CITY OF ALBUQUERQUE

**RE: Stanford Townhomes
424 Stanford Dr. SE
Revised Grading and Drainage Plan
Engineer's Stamp Date: 04/21/20
Hydrology File: K16D084**

Based upon the information provided in your submittal received 04/21/2020, the Revised Grading & Drainage Plan **is not** approved for Building Permit and SO-19 Permit. The following comments need to be addressed for approval of the above referenced project:

GRADING & DRAINAGE PLAN

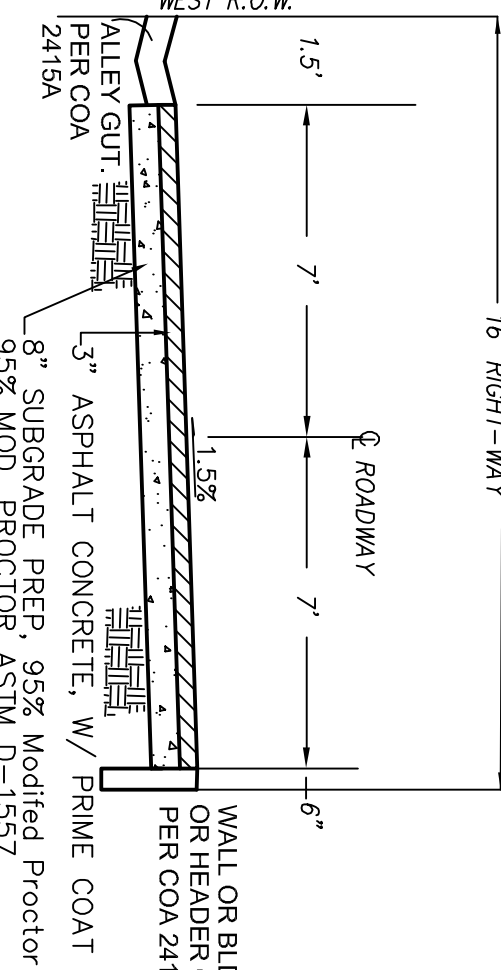
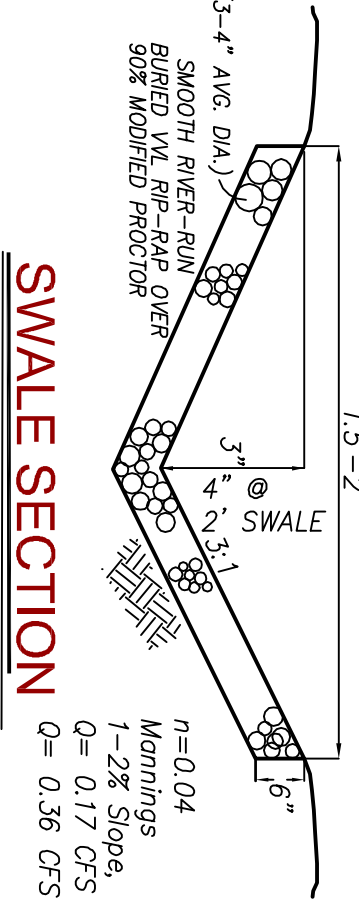
1. Please use the drafting standards outlined in the DPM. Plans need to be black & white with appropriate line weights for existing and proposed items. Color plans are very hard to read.

2. Please remove all interior architecture items for the townhomes. One it's not needed and secondly it is hard to read the finish floor elevation.
3. Please provide the FIRM Map and floodplain note with effective date.

4. The two stormwater quality ponds along Stanford Dr. need an emergency spillway. This can be done with a sidewalk culvert. Just make the invert elevation on the pond side the same elevations as the water surface elevation of the required SWQ volume. Also you can only use one sidewalk culvert if you connect the two ponds with a pvc pipe under the private sidewalk.

5. For the sidewalk culverts, instead of the orifice equation which was used, the broad crest weir equation (equation 6.60 in the DPM) must be used, not the orifice equation. A coefficient of 2.7 is typically used for the equation $Q = CLH^{2/3}$.

6. Please update the SO-19 Permit Notes. See Attachment.
